**To: 700 Ocean Drive ARB Committee**

**Date: 1/2/2025**

**Re: 714 & 716 Ocean Drive – Ivanov New Proposed Residence- Revision based on comments from the ARB and changed to date**

**FRONT ELEVATION**  
3/16" = 1'-0"

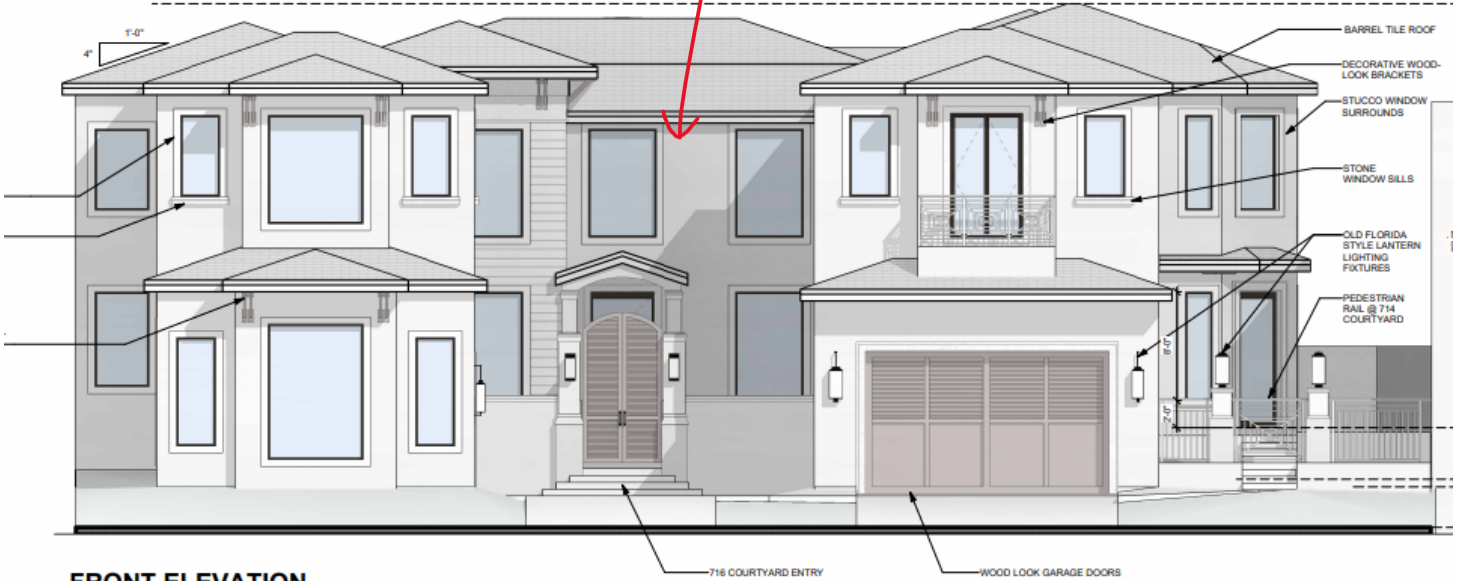
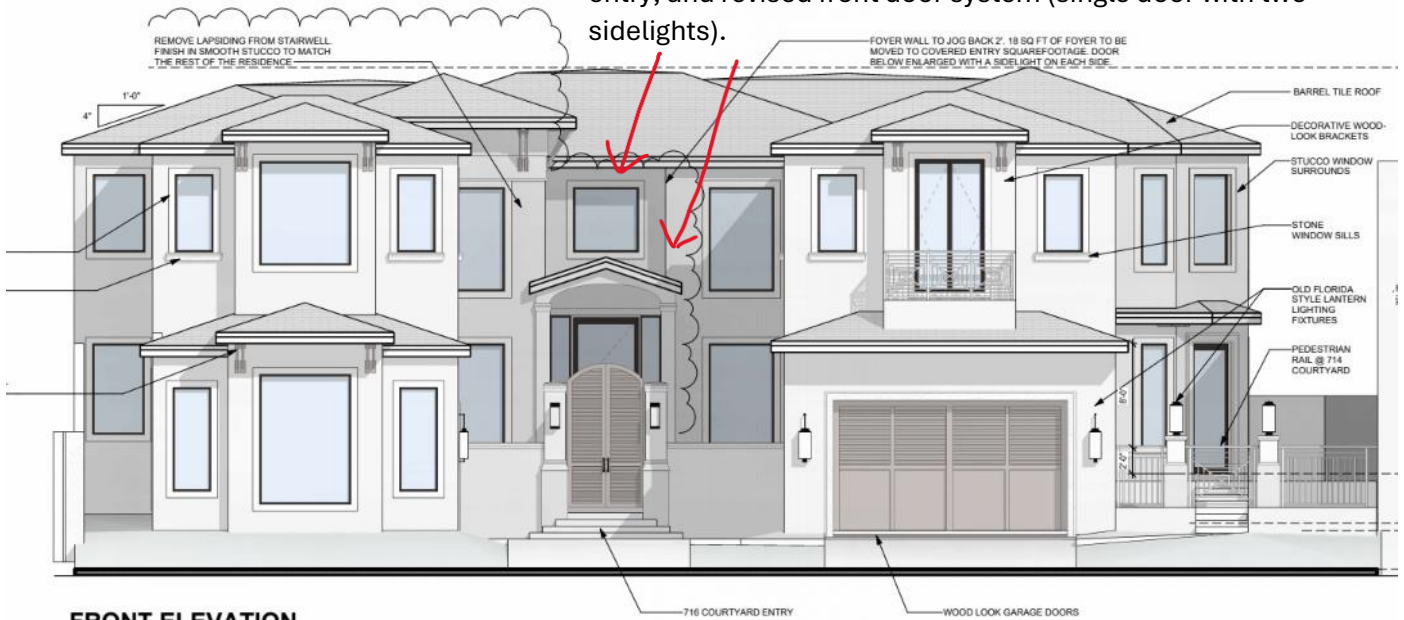
Note: Previous flat wall, small front entry roof.

Note: New higher front entry (more similar to existing homes), dimension change/jog in wall, smaller window above front entry, and revised front door system (single door with two sidelights).

## Data Table Changes

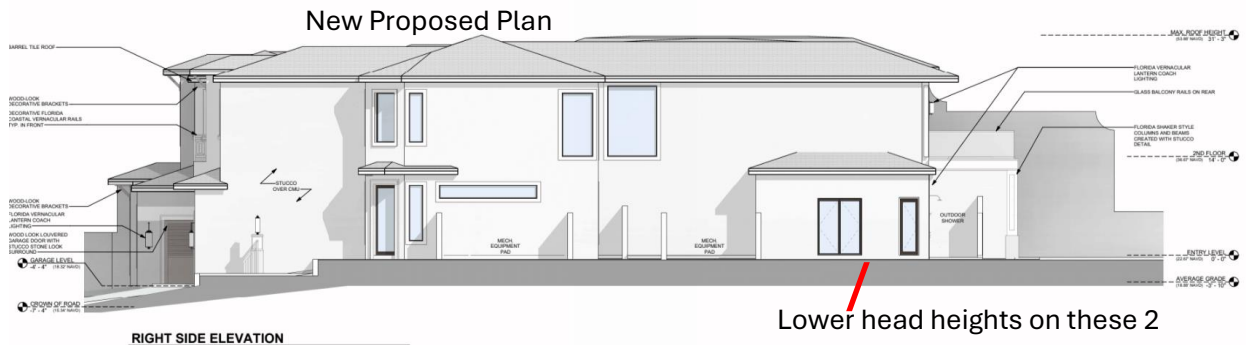
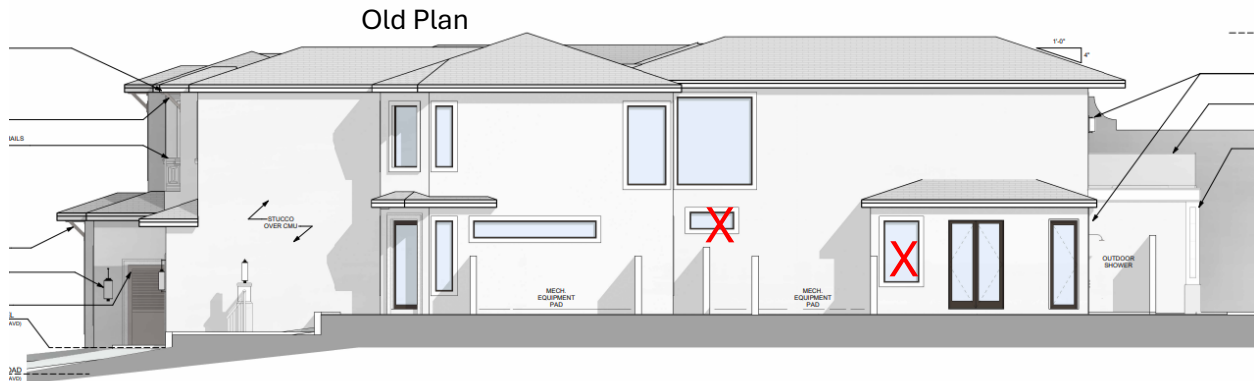
Address	Total Sq. Ft.	Under Air Sq. Ft.	Covered Front Entry Patio	Footprint sq.ft.	Lot Size Sq. Ft.
Proposed New Home <b>(previously Submitted)</b>	14,738 *Includes all areas int and ext under roof	11,981	45 sqft	7,196	38,328
Proposed New Home <b>(New Changes 12-2-24)</b>	14,738 *Includes all areas int and ext under roof (remains the same)	11,963 (decreased 18sqft)	63 sqft (Increased 18sq ft)	7,196 (remains the same)	38,328 (remains the same)

7. Pool- The pool was squared off and the steps entering from the West was removed. Now the steps are on the south side of the pool.

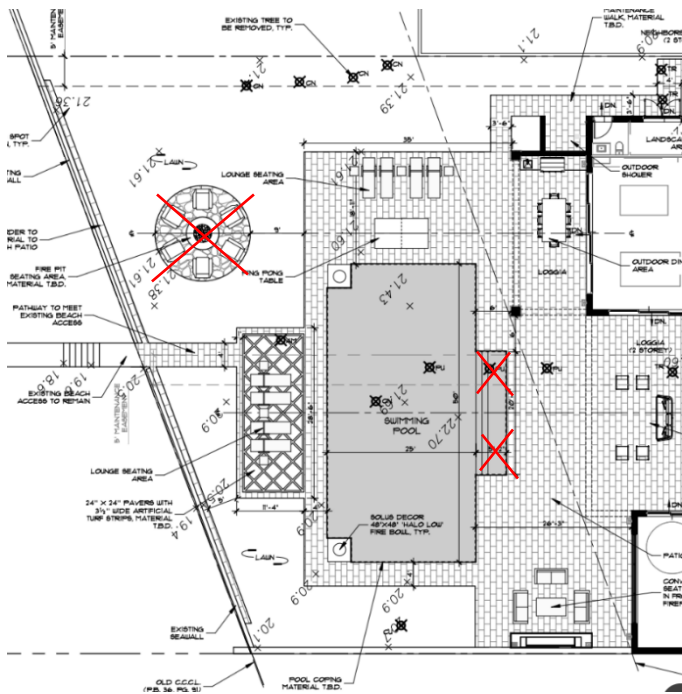
New Proposed – straightened and squared off
